ADDENDUM NO. 1

September 14, 2026

**Perry Meridian High School Phase 2 Renovations
401 W. Meridian School Road
Indianapolis, IN 46217**

SCALE: 1" = 10'-0"

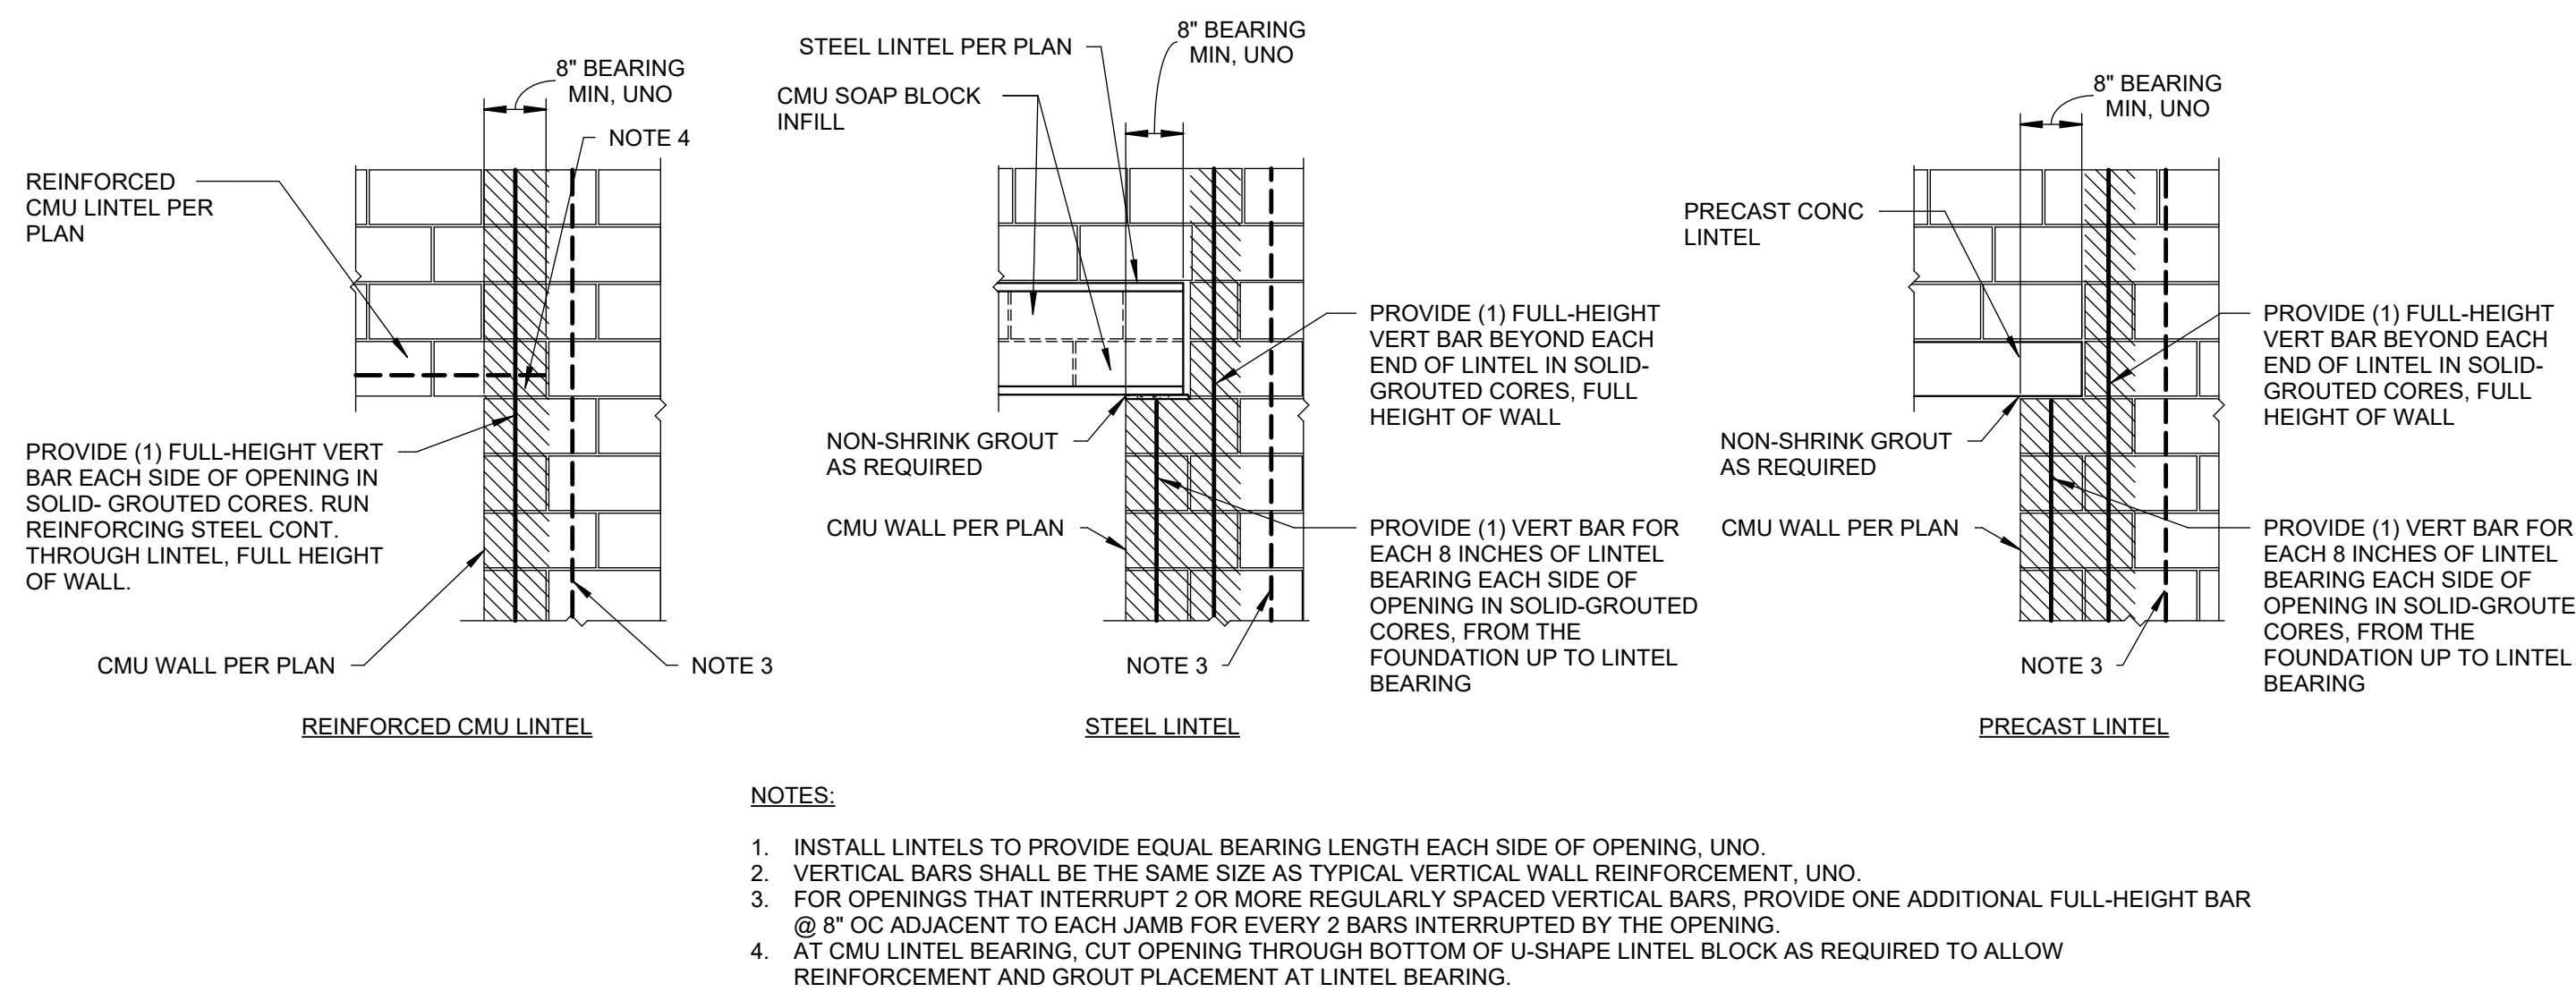
5. **Q:** Note 2 listed in Unit G Partial Structural Plan on sheet S101 states per detail X/X. Please update with detail/sheet and provide said detail/sheet (S502?)

7. Drawing Sheet Number: S101
Drawing Sheet Title: PARTIAL PLANS

- Added slab and section cuts to Unit D PARTIAL PLAN.
- Added section cuts to Unit B and F PARTIAL PLANS.
- Revised plan note 2 and added plan note 3 to PARTIAL PLAN NOTES.
- Revised partial framing to reflect existing conditions and revised plan notes for Unit G.

- a. See attached revised structural drawings in addendum 001.
6. **Q:** Roofing plans include elevation and section call outs for interiors. These are not relevant and should be removed.

S502

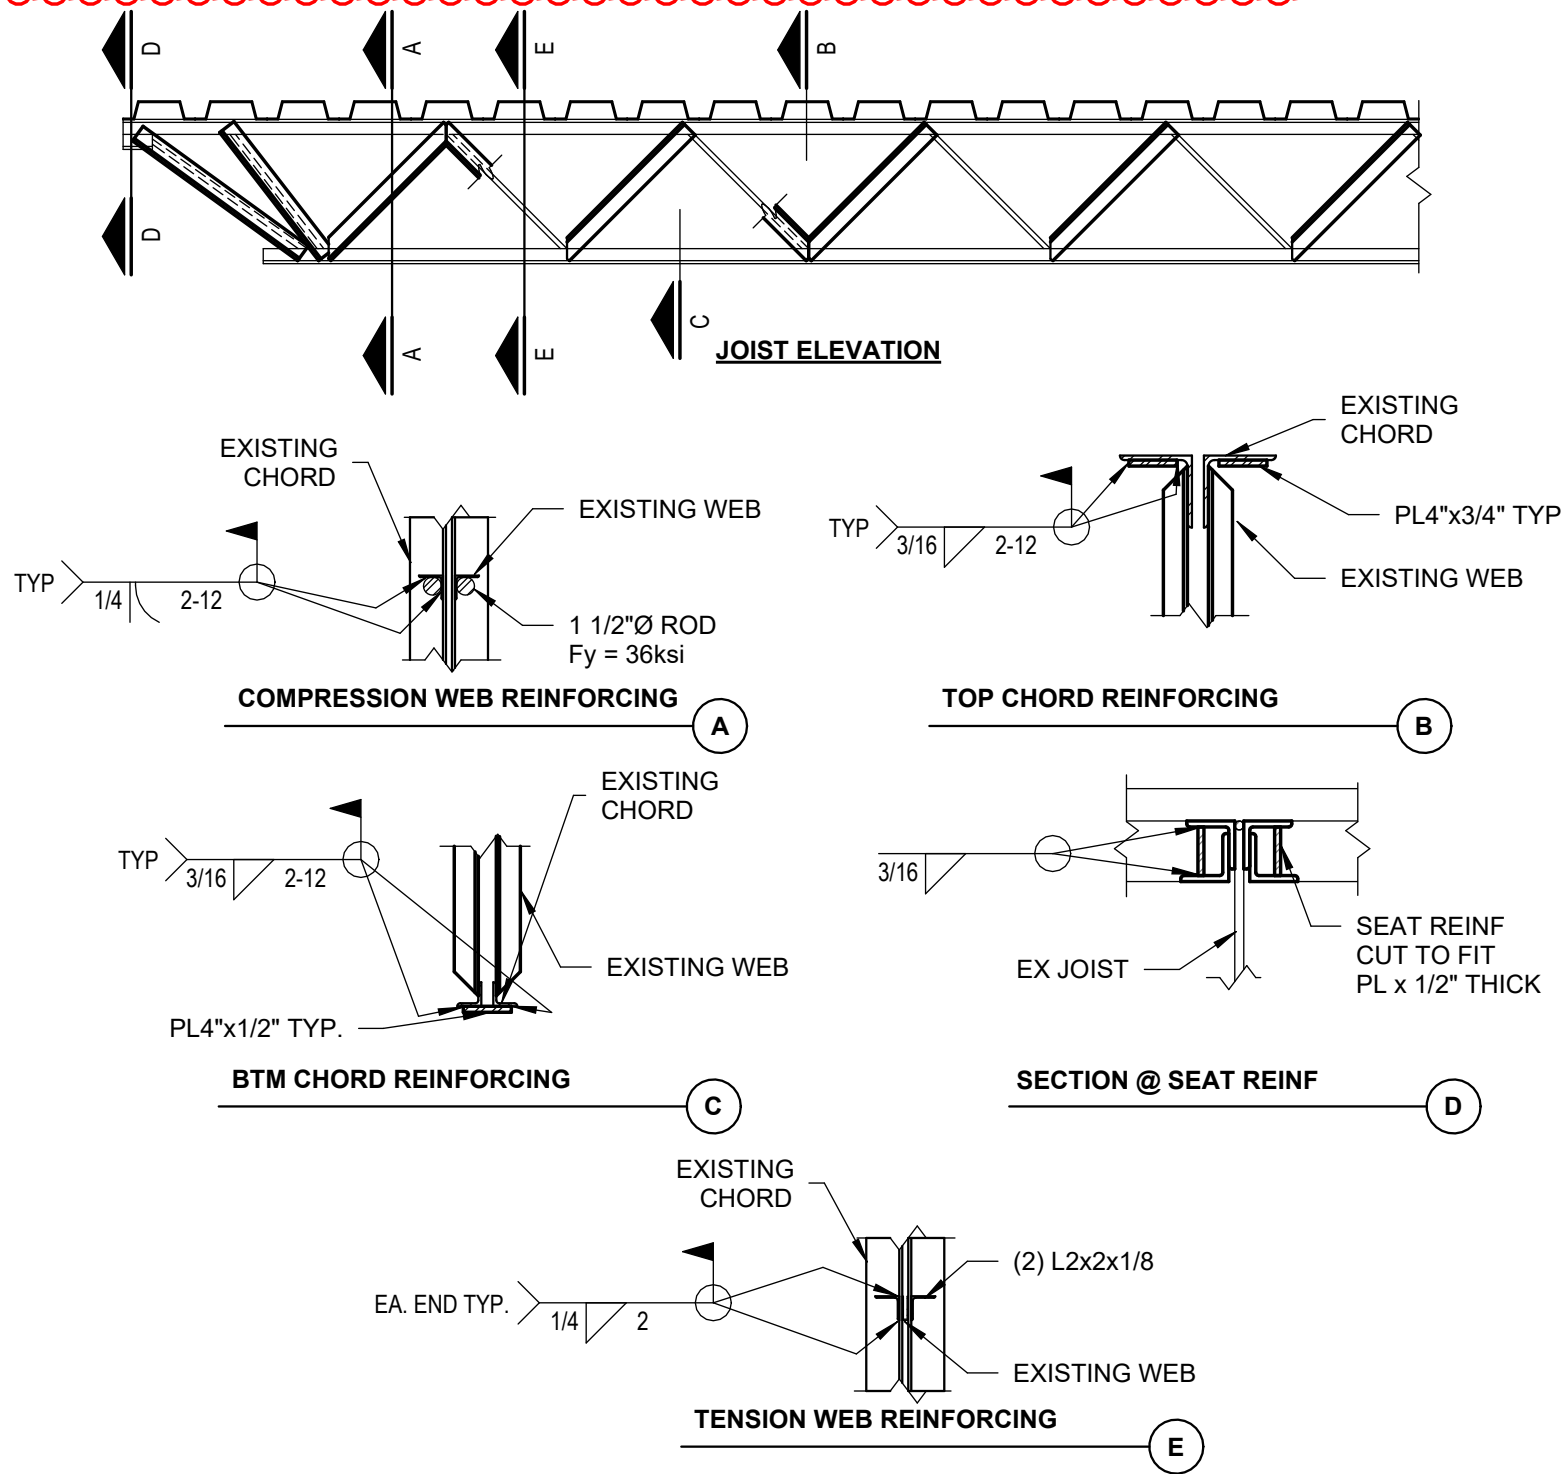
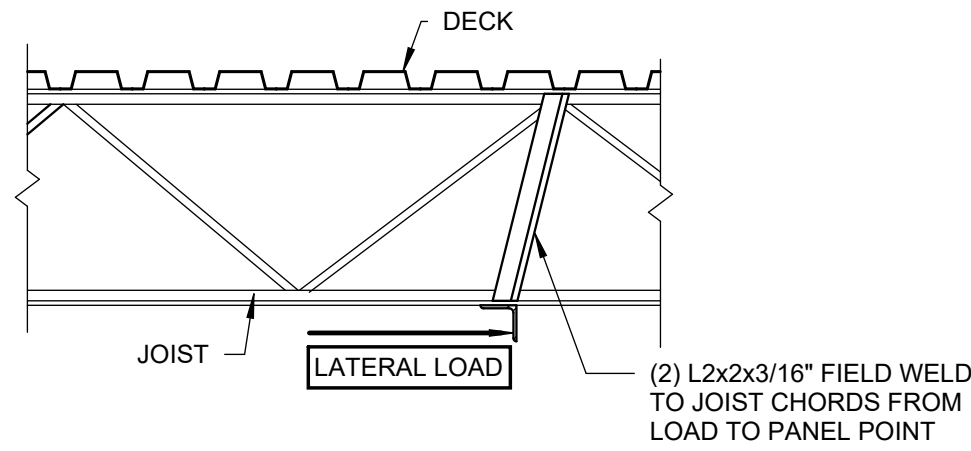
9. Drawing Sheet Number: S502
Drawing Sheet Title: EXISTING JOINT REINFORCING

- Revised notes in detail 1.

AD102D

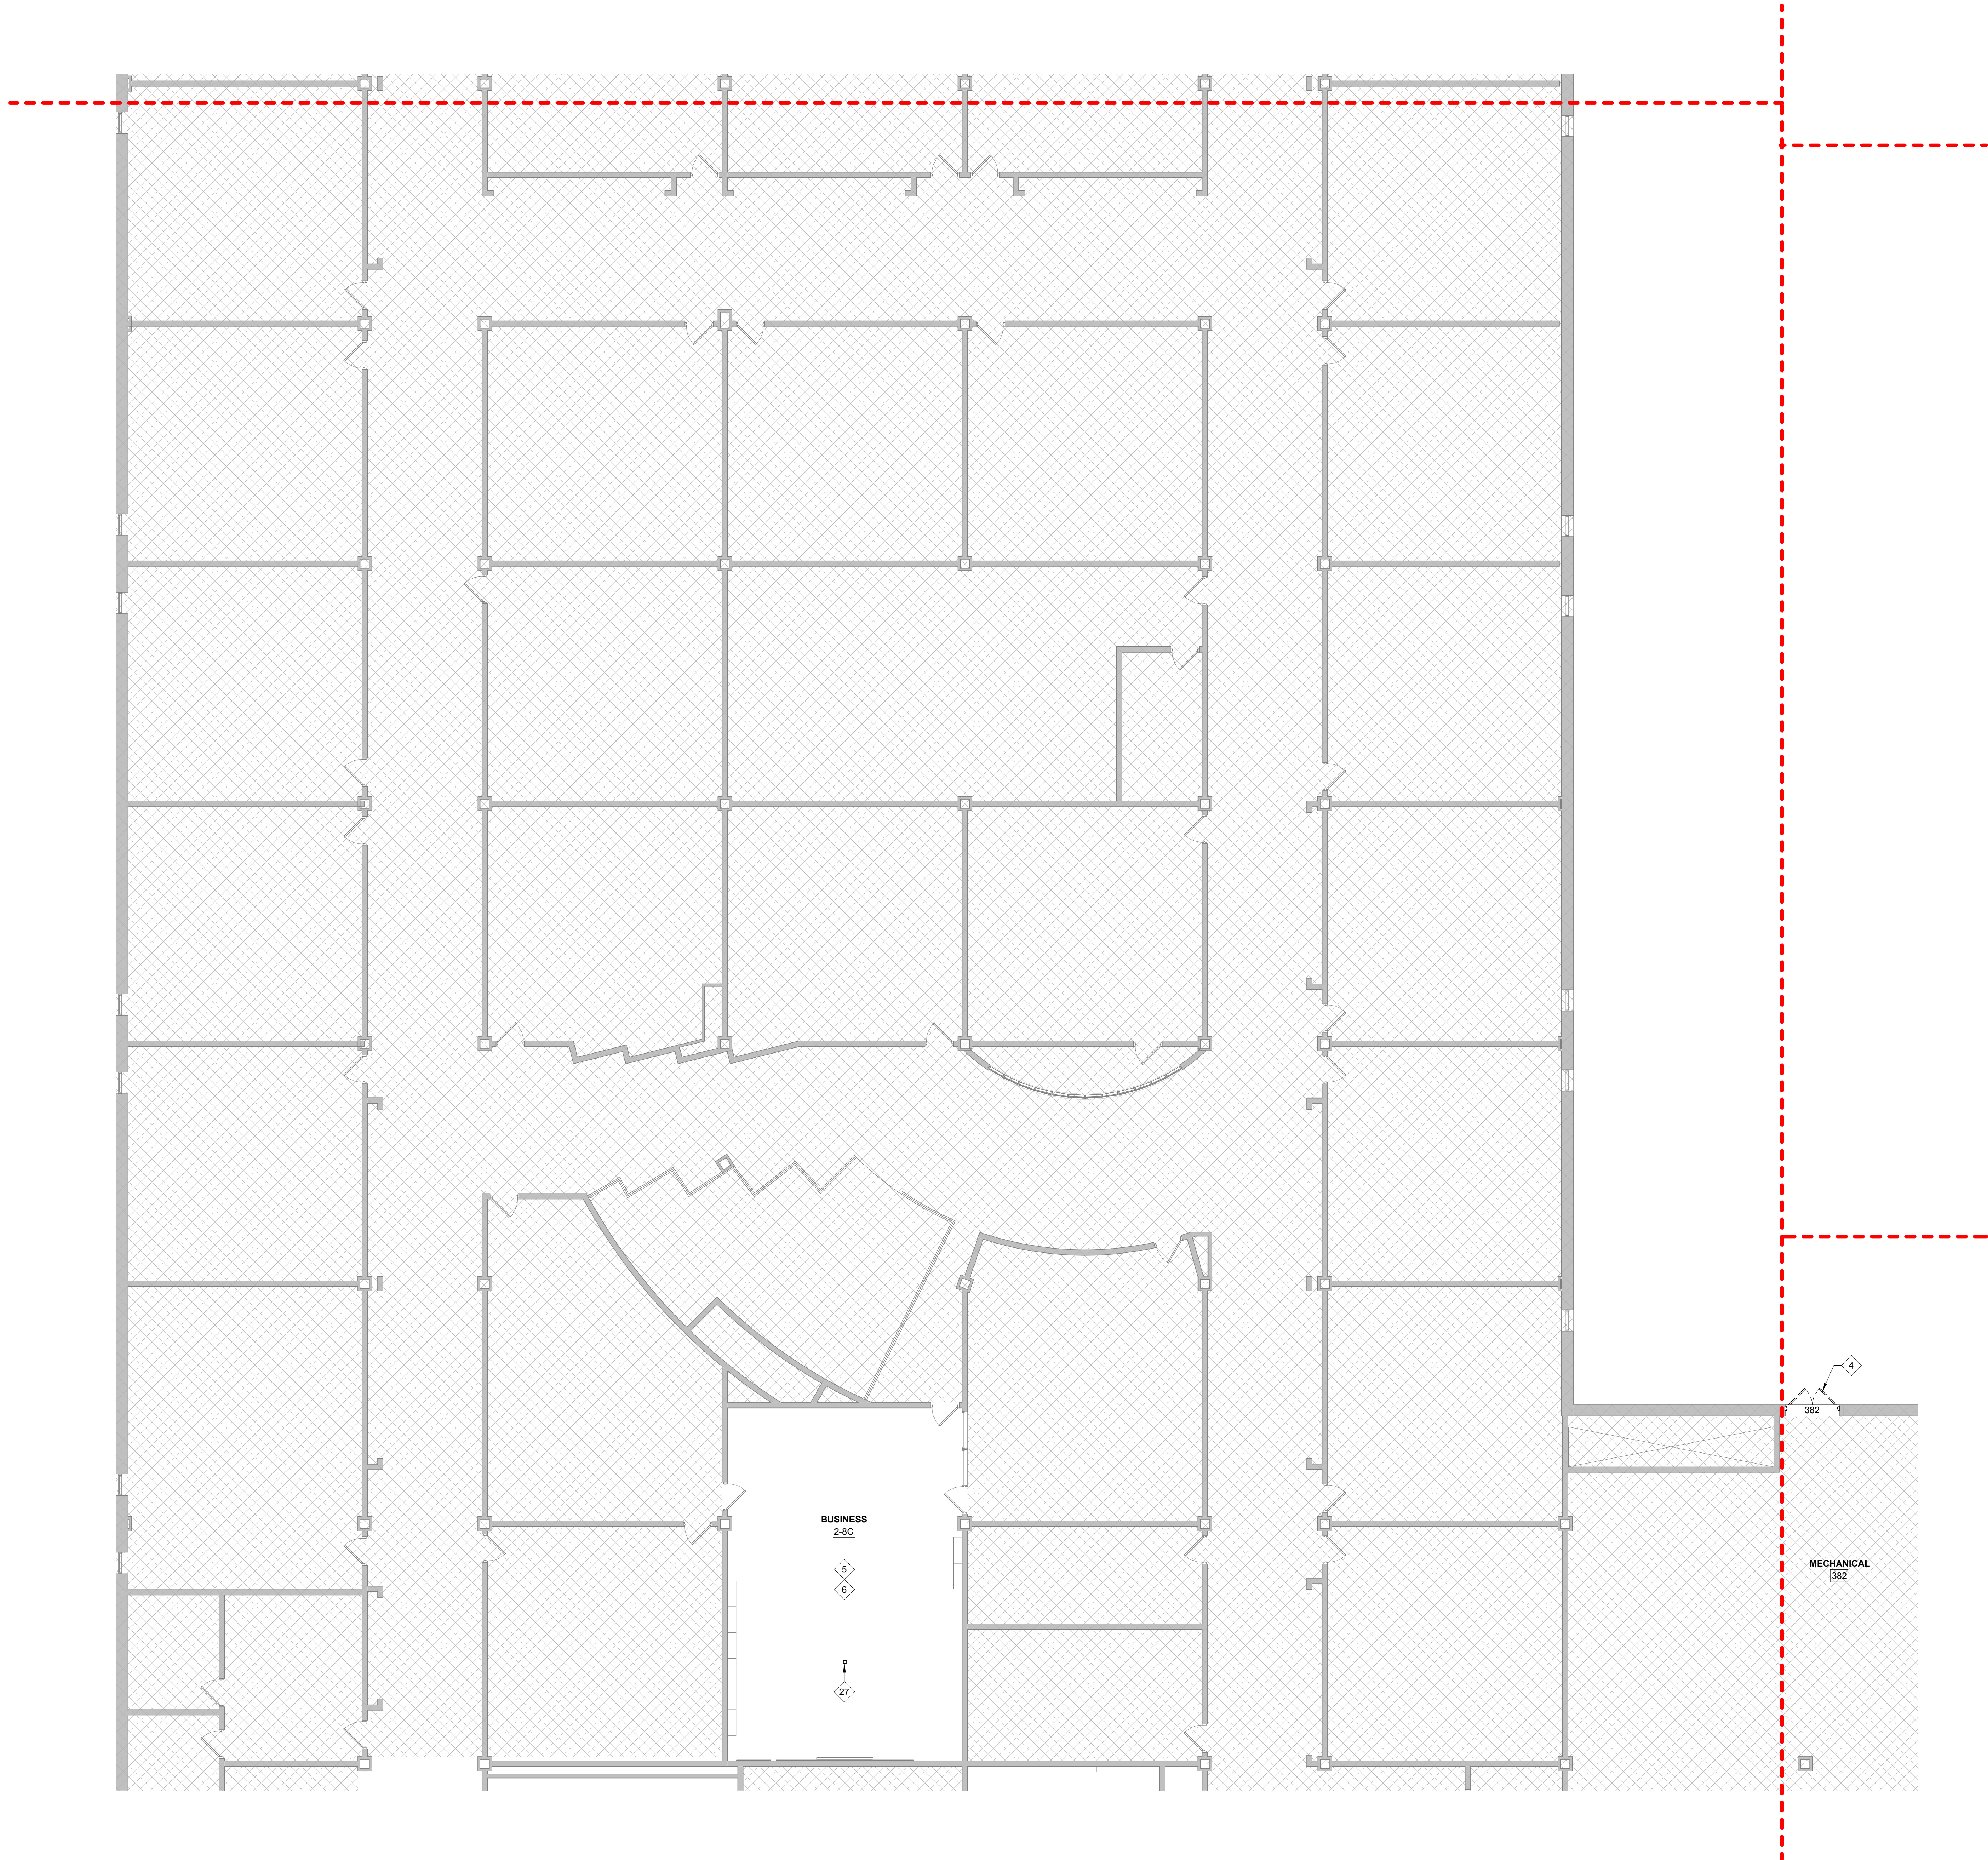
10. Drawing Sheet Number: AD102D
Drawing Sheet Title: DEMOLITION PLAN – SECOND FLOOR – UNIT D

- Sheet added to include door 385 in scope of work.
